This package is intended to accompany the Early Design Guidance Package dated 9 January 2012 & the Design Recommendation Package dated 15 October 2012.

Early Design Guidance Meeting 01.09.2012	Design Review Recommendation Meeting 10.15.2012	GFA Response 10.23.2012
A. Site Planning			
A-4 Human Activity. New development should be sited and designed to encourage human activity on the street. Early Design Guidance #3012712 Page 5 of 8.	At the Early Design Guidance Meeting, the Board did not note this as a high priority, but asked that the applicant consider how the building meets the street with respect to scale, how it addresses its impact on human activity, and how vehicles and people will interact.	<p>CP: Thinks there is no place for people to look at cars inside but not have to buy, no user experience</p> <p>SH: Has hesitation regarding two things, regarding user experience at the ground level, and the pedestrian approach at ground level</p> <p>SH: The pedestrian experience on site must be addressed more to accommodate and enhance the excitement of people coming to buy cars.</p> <p>JH: Our focus should be more on the experience of right of way than for a customer.</p> <p>MZ: It s

EAST ELEVATION

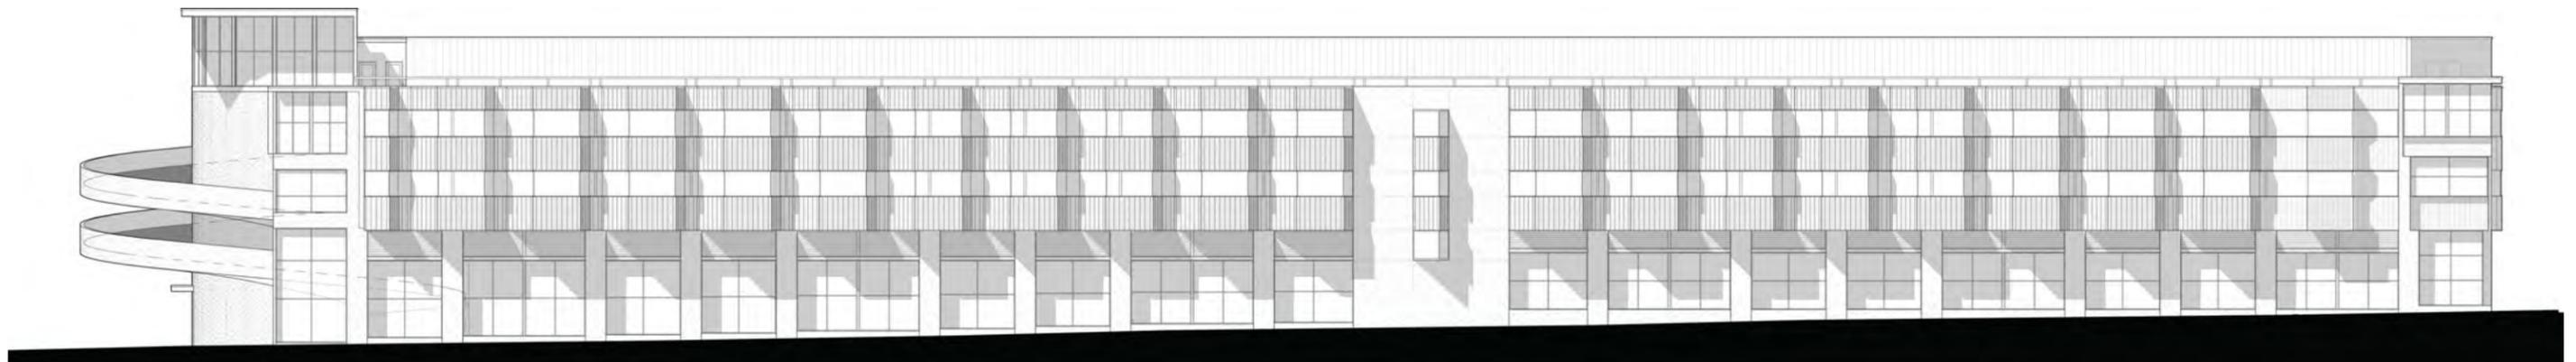
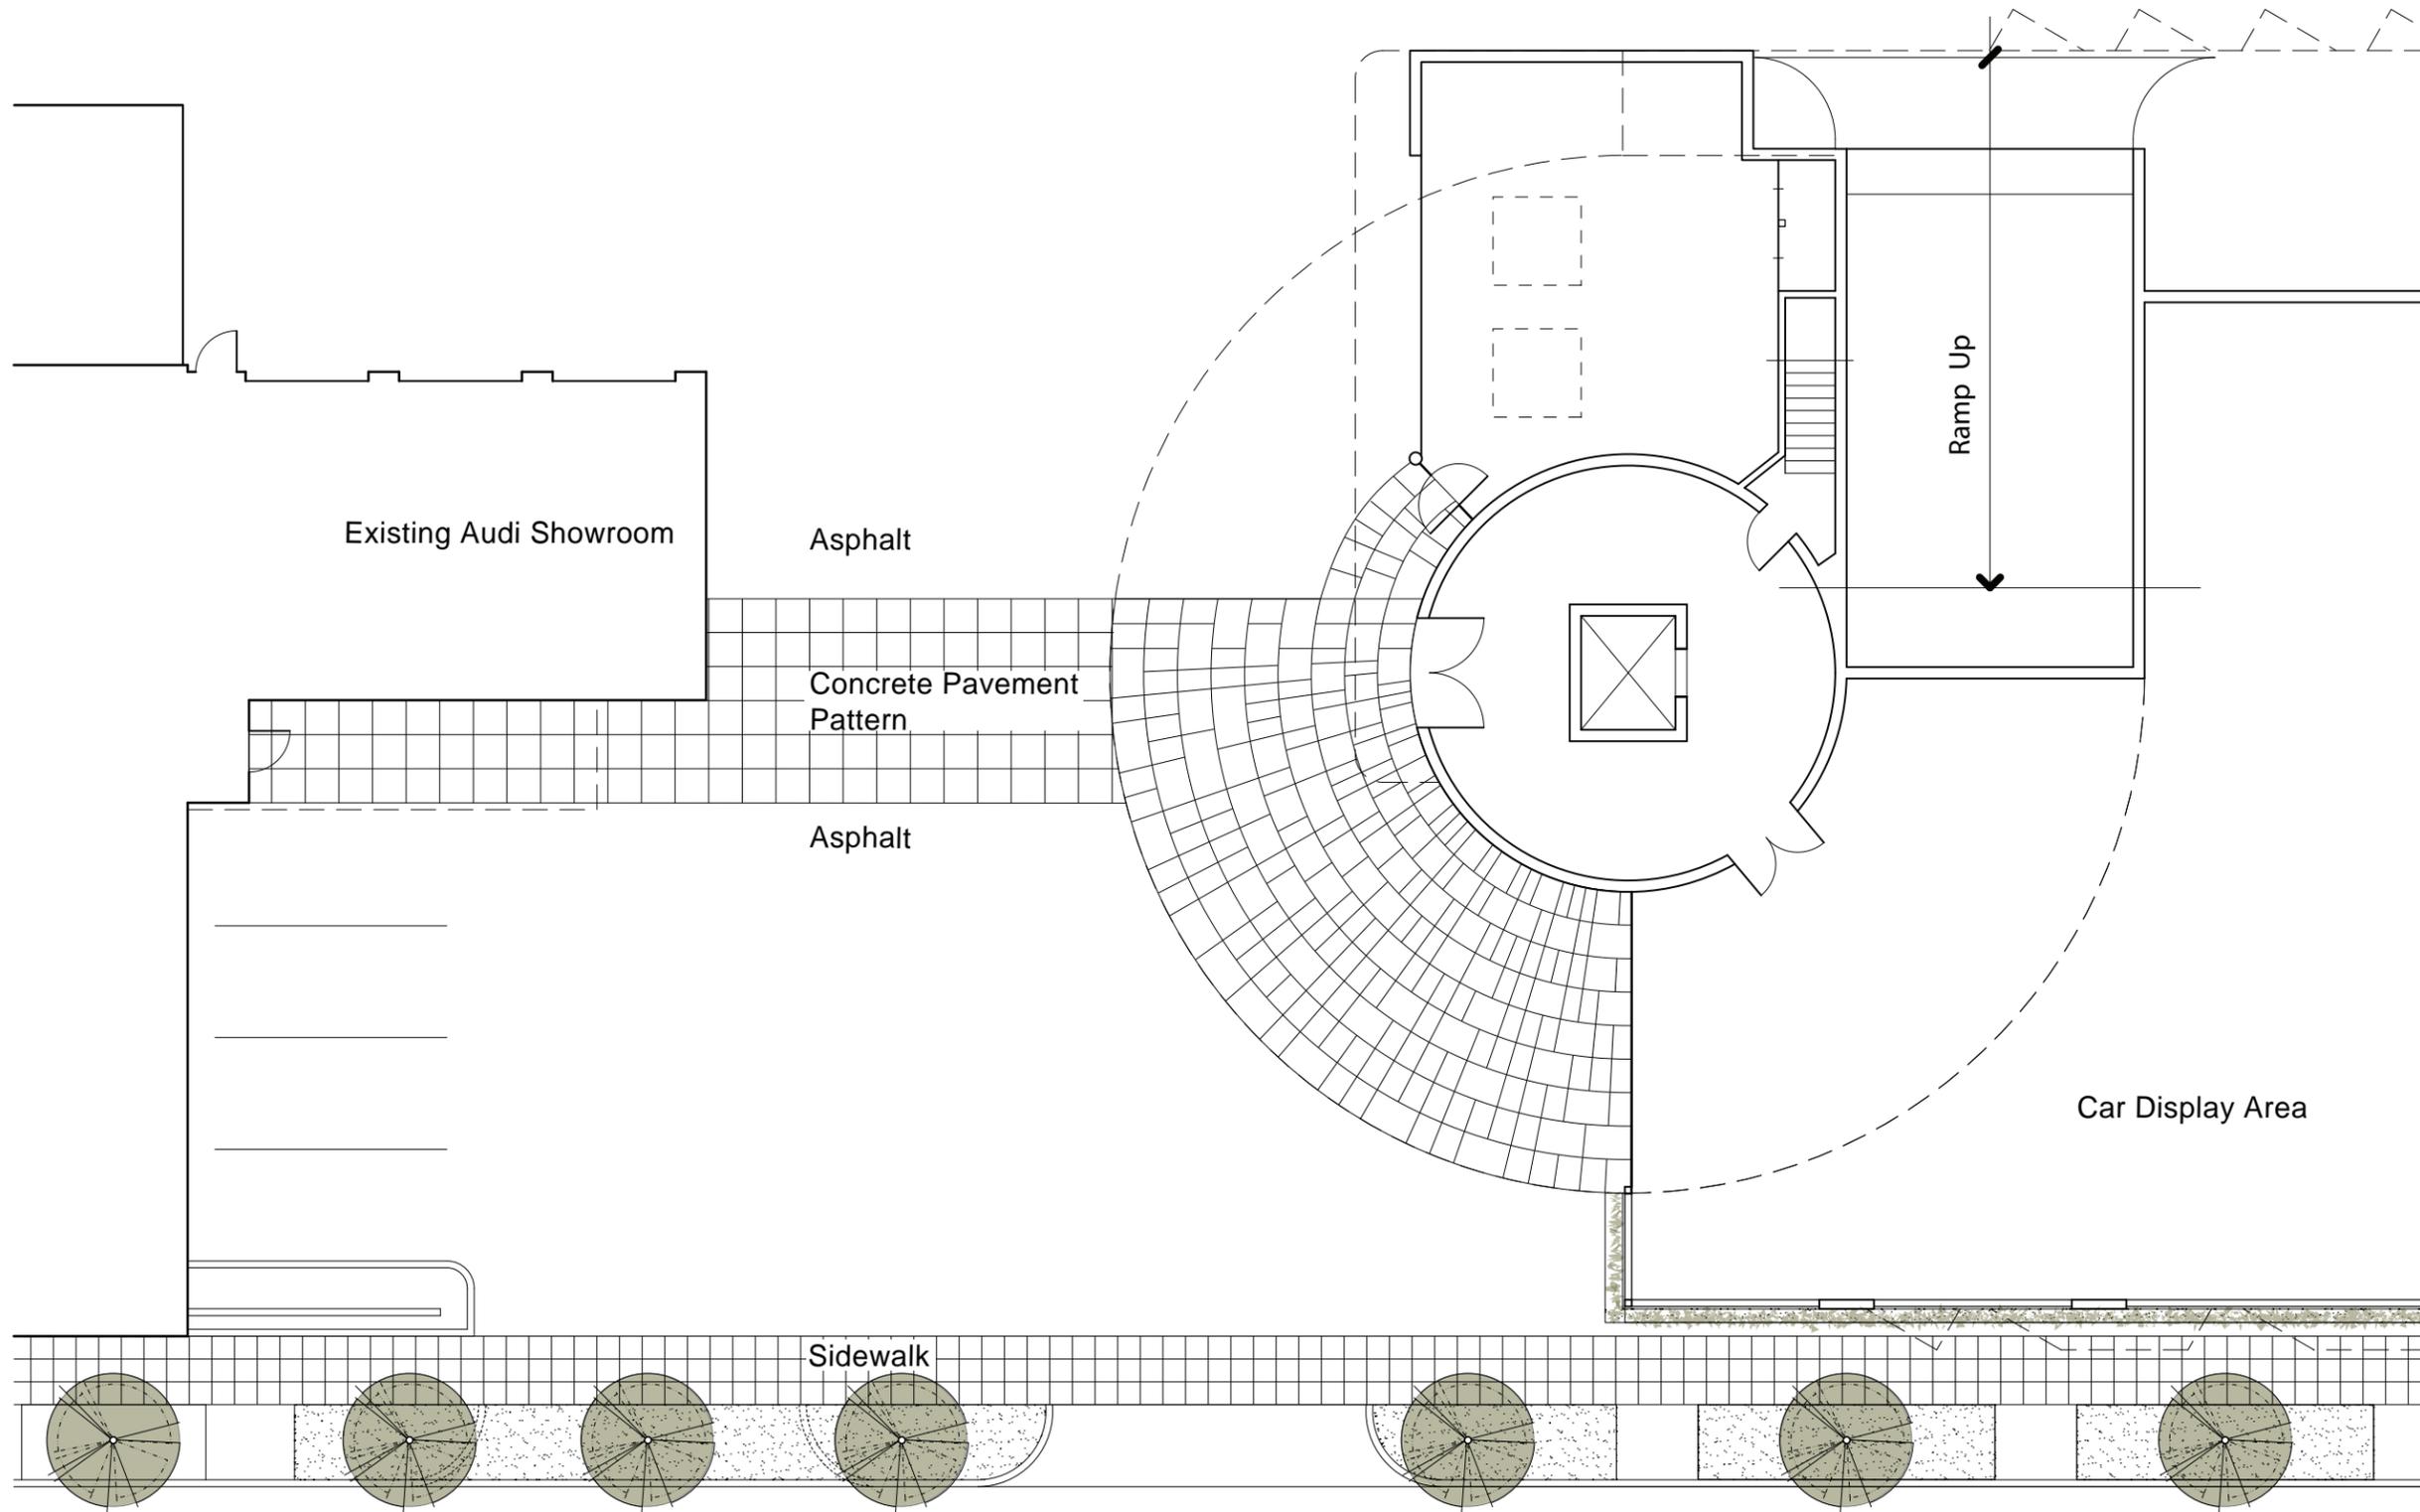
JH: “The fact that the head and sill-height of the bays is all the same is disappointing.”

SH: “The edge is unnecessarily complicated, pull that edge back to the end of the bays and let the ramp continue through further.”

JH: “The point is that something needs to anchor that corner, along that façade; the edges need to be anchored.”

JH: “Look at doing different studies of the elevation to not give it such a ribbon effect.”

At the Design Review Meeting the Board had numerous aesthetic suggestions, noting disappointment with the East and North facades, as well as the treatment of the NE & SE corners. One member of the Board suggested pursuing a monochromatic treatment of windows on the NE corner in order to simplify its appearance. Another member of the Board suggested raising the concrete frame of the NE corner to be taller than the North & East facades around it. Further discussion of fenestration by the board emphasized a desire to see studies of proportions for window frames and mullions on the first floor, and to eliminate or ameliorate the ribbon window typology on the second and third floors. The Board as a whole expressed a desire for the Lantern to be lightened aesthetically, and that its cap be more akin in form to the ramp design below it. The Board’s discussion of the North & East facades emphasized a desire for more complex Structural Building Overhang arrangements, pointing to earlier schemes from the Early Design Guidance package and their use of vertical elements as punctuation in the façade. In addressing the SE corner, the Board expressed a desire that it not be obscured by signage, and that the form emphasize the ramp crashing from exterior to interior.

Design Departure Request 1

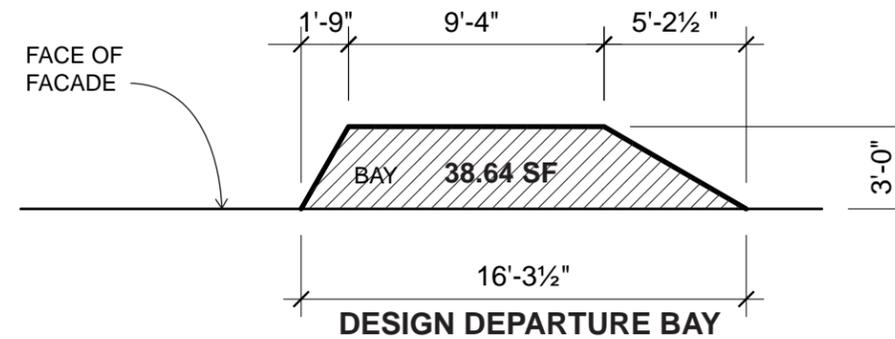
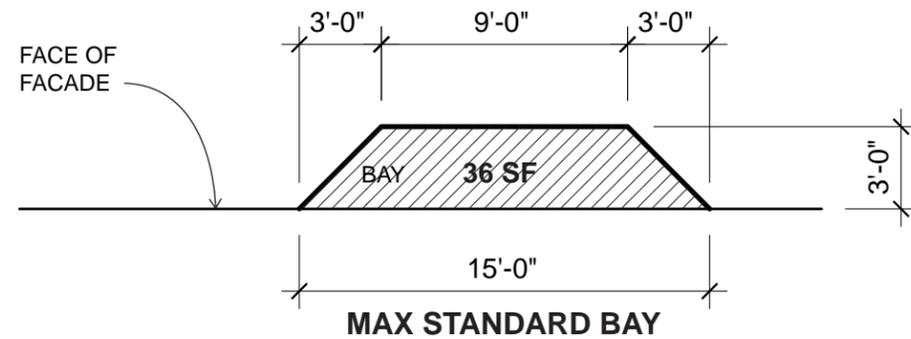
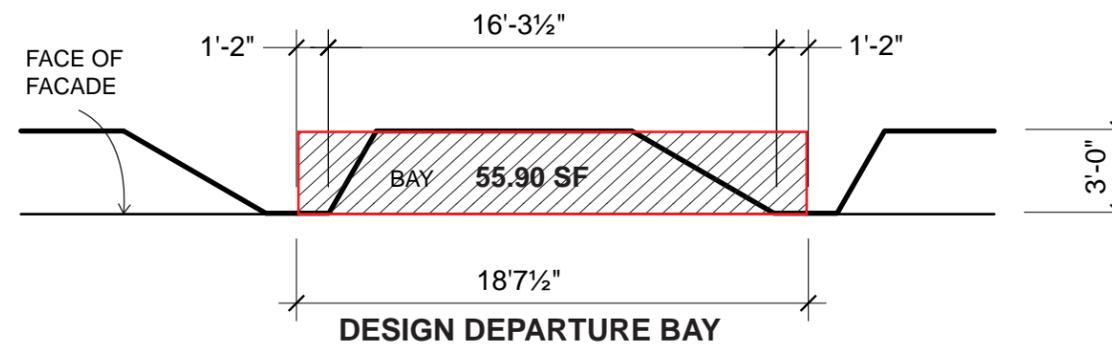
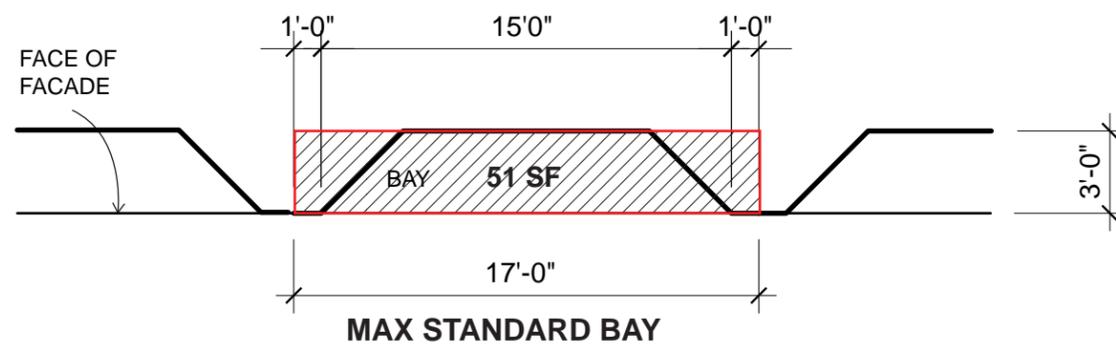
We are requesting a design departure for structural building overhangs (S.B.O.), Section 23.53.035. This departure was suggested by one of the early design guidance board members. He thought a larger bay (S.B.O. in the code's language) that accommodated the front ends of two cars instead of a single car, would better suit the scale of the building on the 11th avenue facade. We agree.

LENGTH	AREA	AREA PER REPEATED BAY
MAX. STANDARD BAY	15.00'	36.00 SF	70.6%
PROPOSED DESIGN DEPARTURE BAY	16.29'	38.64 SF	69.1%
DIFFERENCE BET. STANDARD & DEPARTURE	8.6% GREATER	7.3% GREATER	1.5% LESS

Design Departure Request 2

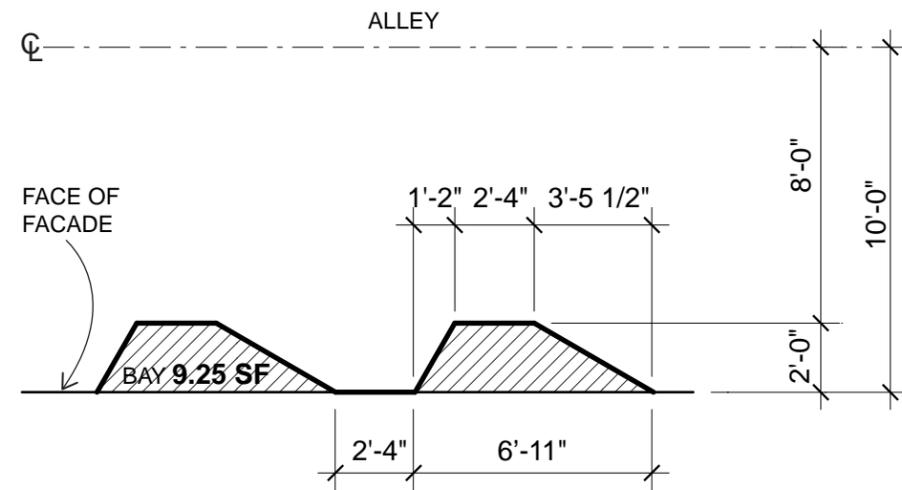
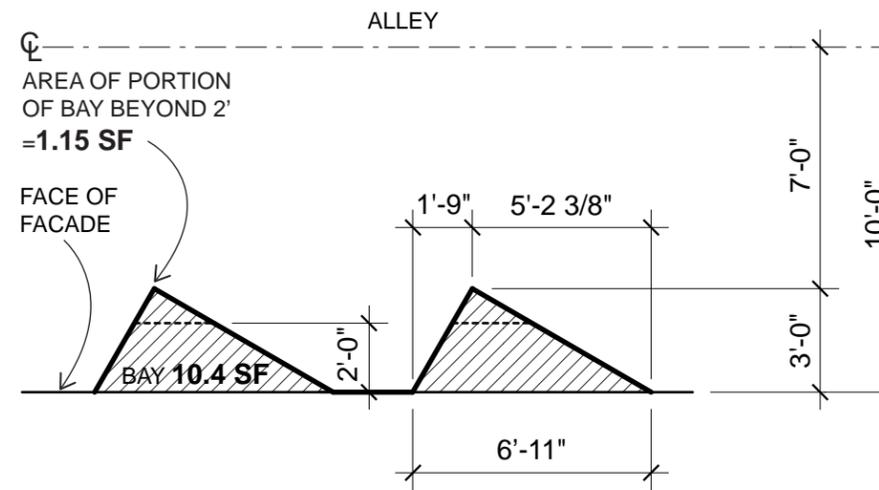
We are requesting a design departure for structural building overhangs (S.B.O.), defined in section 23.53.035 of the land use code. The request is regarding the depth of all 43 bays in the alley.

DISTANCE TO ALLEY CENTERLINE	AREA OF BAY BEYOND 2'
STANDARD BAY	8.00'	0.00 SF
PROPOSED DESIGN DEPARTURE BAY	7.00'	1.15 SF
DIFFERENCE BET. STANDARD & DEPARTURE	1' CLOSER TO CENTERLINE	1.15 SF GREATER

Design Departure Request 3

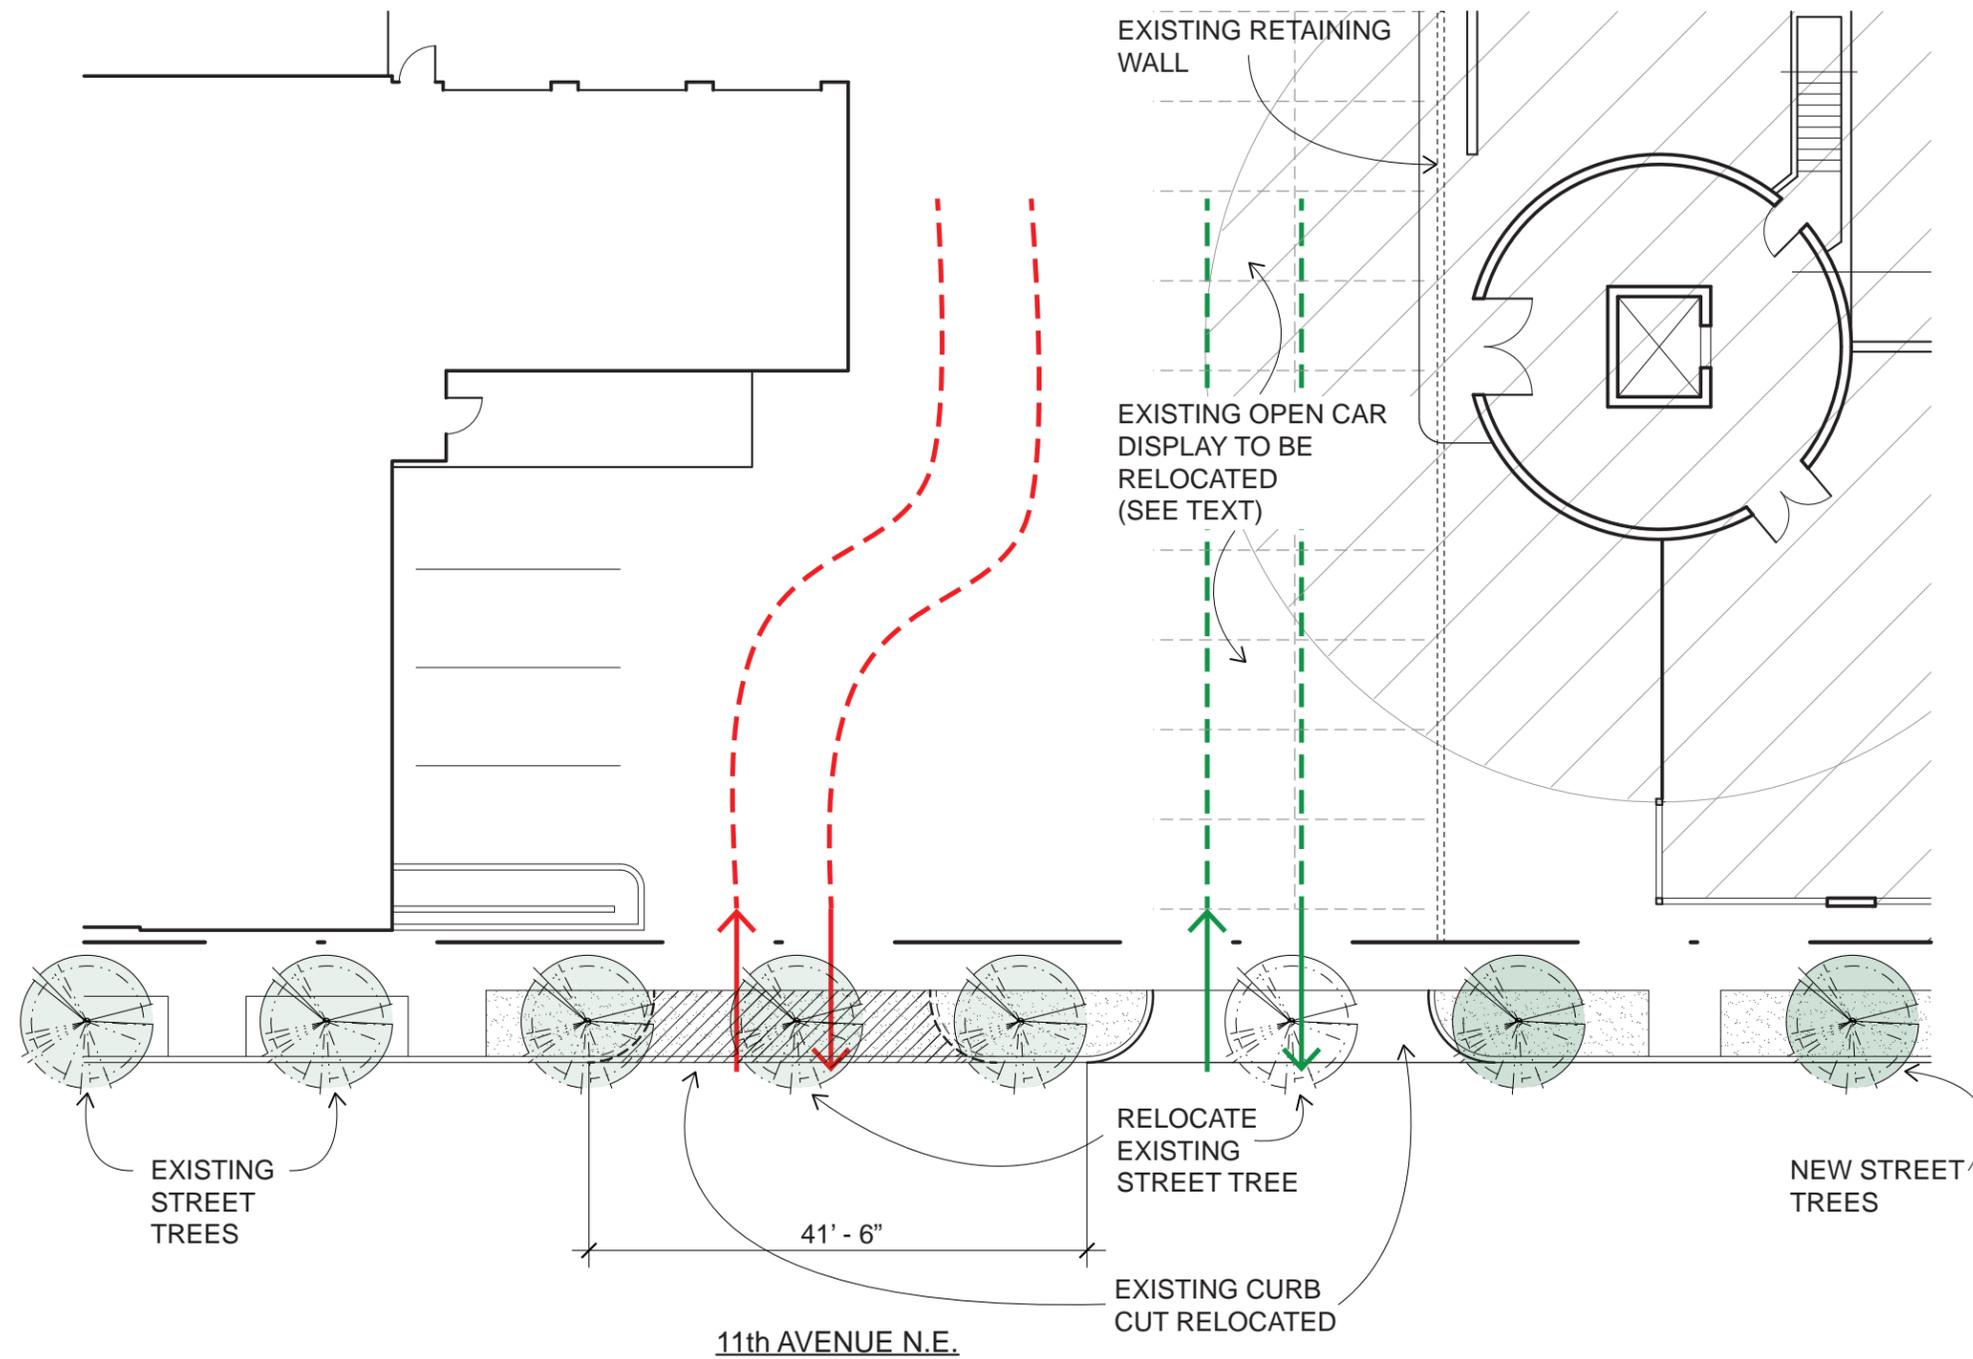
We are requesting a design departure from section 23.47A.032 Of the land use code, which requires access to parking be via an alley, if the alley meets certain standards. We are proposing to relocate an existing curb cut on 11th Ave N.E. approximately 40 feet North of its existing location. The request is made because the proposed new building will allow the existing open car display area that offsets the route to 11th Ave N.E. from the alley to be moved inside. This will allow a safer and more direct access on and off of the site from 11th Ave N.E.

It should be noted that in addition to the request to relocate the southern most curb cut, we are eliminating 2 existing functional and 5 existing non functional curb cuts along 11th Ave N.E., making way for expanded landscaping.
